Re: Walla Walla Solar Farm Amendment Report

This Amendment Report accompanies the Response to Submissions report (RTS) for the Walla Walla Solar Farm ('the proposal'). It details the amendments to the State Significant Development (SSD) Application # 9874. The amendments to the design of the solar farm layout have been proposed to reduce visual amenity impacts, specifically for Orange Grove Gardens, a local wedding venue and ecolodge business and meet the access and asset protection requirements of APA Group's gas pipeline, which runs through the development site. In order to comply with the Natural Resources Access Regulator (NRAR) request to retain riparian zones under the *Guidelines for controlled activities on waterfront land* published by the NSW Department of Industry (DPI) in 2018, FRV Services Australia (FRV) have guaranteed riparian corridors for Back Creek of 30 m and Middle Creek 20 m.

Appendix A Amendments

Figure 1 Changes to the proposal design to meet APA Group's requirements

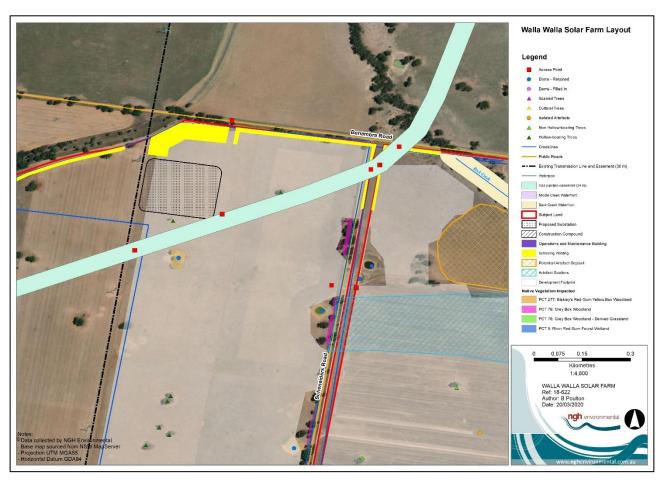
APA Group lodged a neutral submission regarding the proposal requesting a number of requirements to ensure their unrestricted access to their gas pipeline and assurance that the 24 m gas pipeline easement would remain free of obstructions over the life of the proposal (refer 4.1.2 of the RTS report).

To comply with APA Group's request, FRV have made the following changes to the proposal design shown in Figure 1:

- Removal of screening vegetation from the gas pipeline easement.
- Four additional access points to enable APA Group unrestricted access to their gas pipeline.

Figure 2 Revised visual impact mitigation for Orange Grove Gardens

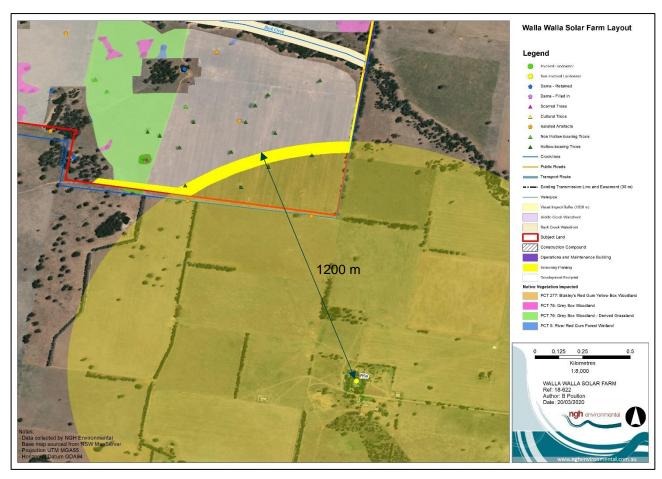
As an additional measure and effort by FRV to address the visual impacts during construction and in the medium term to ensure that the Orange Grove Gardens business is protected, FRV have decided to implement an additional setback, so that the total distance from the wedding venue to any solar infrastructure has been increased from 880 m to 1200 m. As shown in Figure 2, the 50 m vegetation screening buffer would be retained and before this, the south eastern corner of the development site would be retained for cropping by the landholder to maintain the existing agricultural ambiance.

- Altered the solar array design layout, setting back the solar arrays so that the total distance between Orange Grove Gardens' built structures and the nearest panels is 1200 m.

- An arrangement with the landowner to crop the south eastern corner of the development site to maintain agricultural views for wedding functions.
- FRV will implement an extensive 50 m vegetation buffer along the full length of the southern development boundary. Following this 50 m buffer, an additional 5 m vegetation buffer would travel the full length of the eastern boundary to complement the existing mature vegetation that is present. A detailed landscaping plan has been created, which includes:

- From this vegetation buffer, a further 10 m setback would occur for the APZ.
- After the APZ, only then would the solar farm security fence be installed so it can be screened by the proposed vegetation.

- An additional 5 m minimum setback would occur before the solar array would be installed.

Figure 3 Riparian exclusion zone implemented for Middle Creek

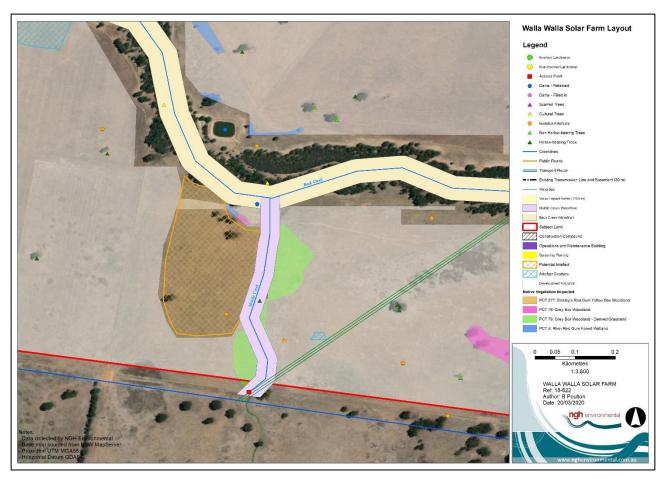
Following the submission from DPI Water and NRAR, FRV have reassessed the proposal design to ensure that it meets the requested riparian exclusion zones of 30 m for Back Creek and 20 m for Middle Creek. As a large portion of Back Creek has existing retained vegetation occupied by Squirrel Gliders and other wildlife, the design proposed in the EIS already avoided land within 30 m of Back Creek. The design proposed in the EIS also avoided a good portion of the riparian zone for Middle Creek and this has since been modified to ensure a 20 m exclusion zone for the length of Middle Creek within the development site as shown in Figure 3.
